SUITE 318
ORIGINAL LAYOUT
INVENTORY
SUITE

SUITE 318 - SAG HARBOUR

Royal Pine Homes 25 Baker Hill Blvd - Stouffville, ON Feb 14, 2018

SAG HARBOUR: 318

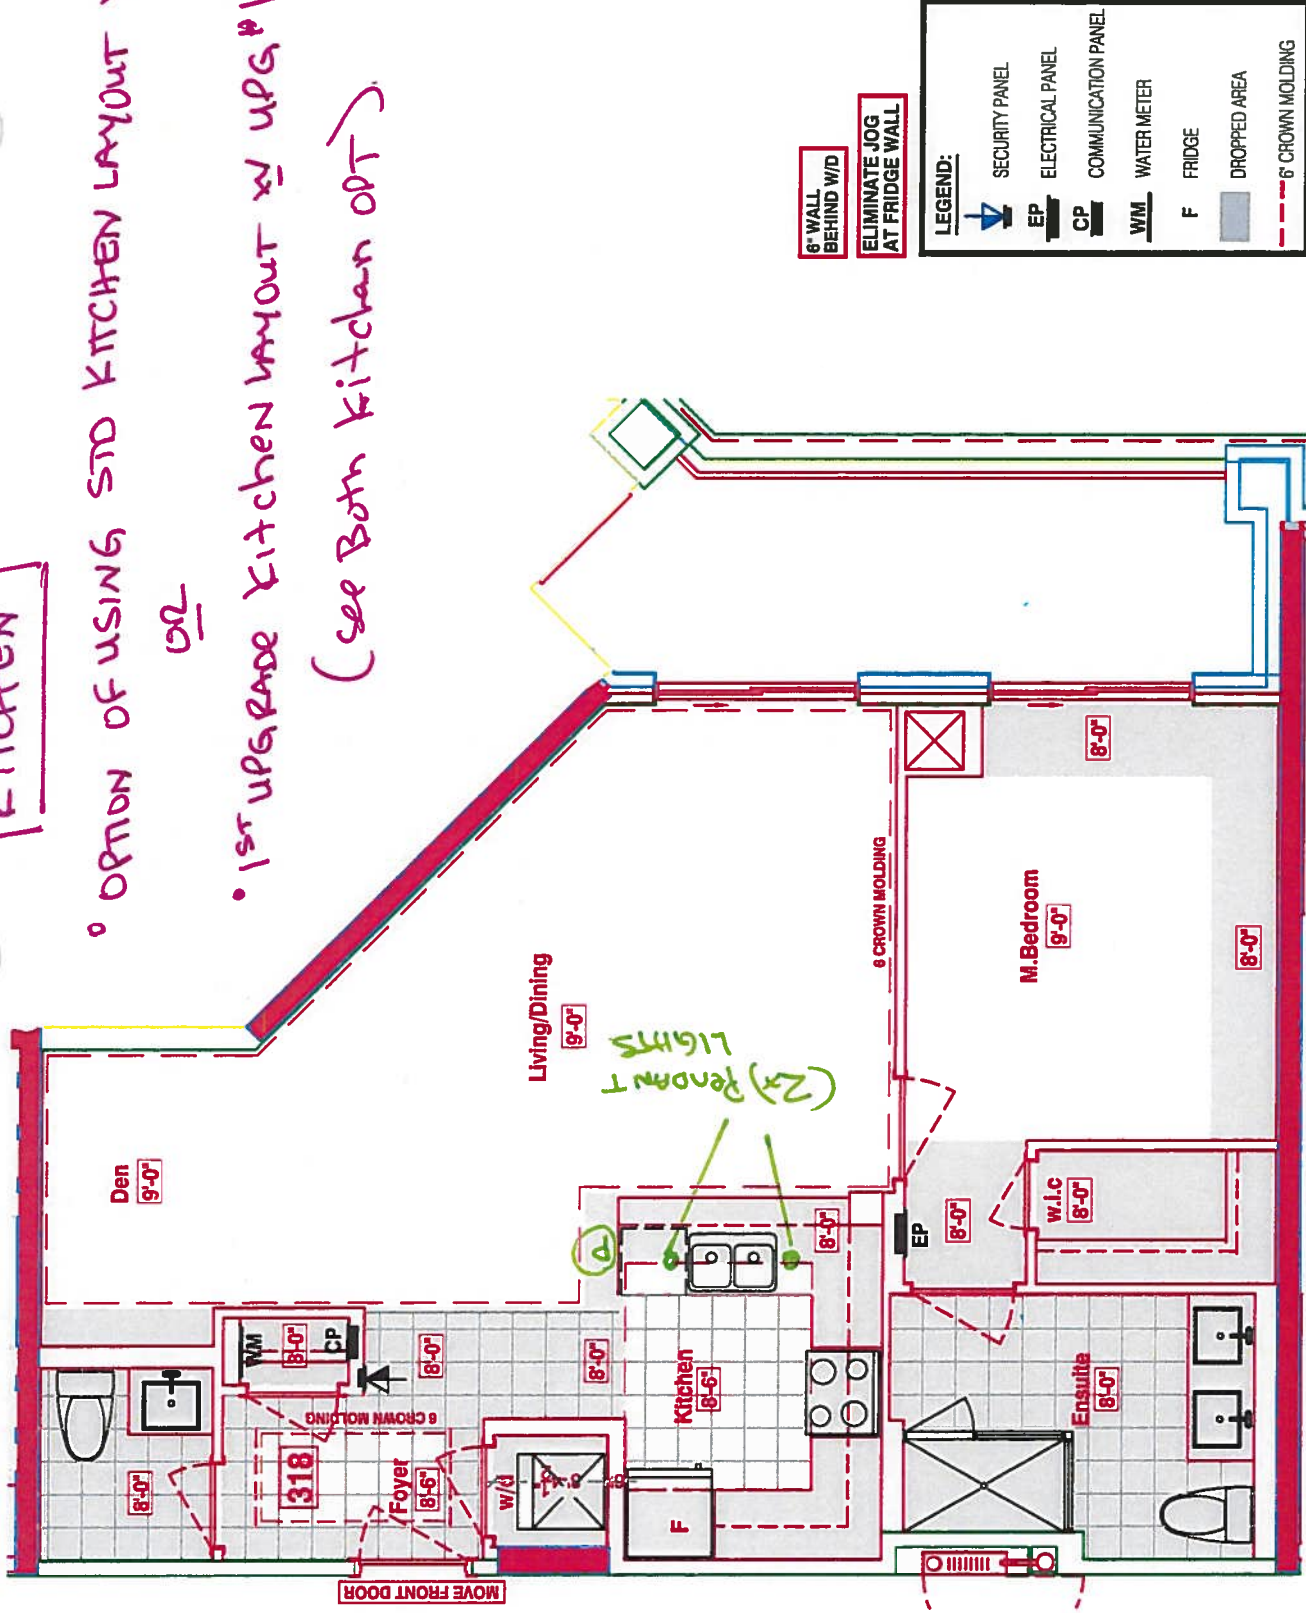
- MOVE FRONT DOOR (FOR 6" WALL BEHIND WASHER/ DRYER)

* MOVE FRONT DOOR
DUE TO 6" STRAP WALL
BEHIND WASH/DRYER

- OPTION OF USING STD KITCHEN LAYOUT W/ STD APPLIANCE PACKAGES
- OR
- 1ST UPGRADE KITCHEN LAYOUT W/ UPG¹- APPLIANCE PACKAGES
(see Both Kitchen OPT)
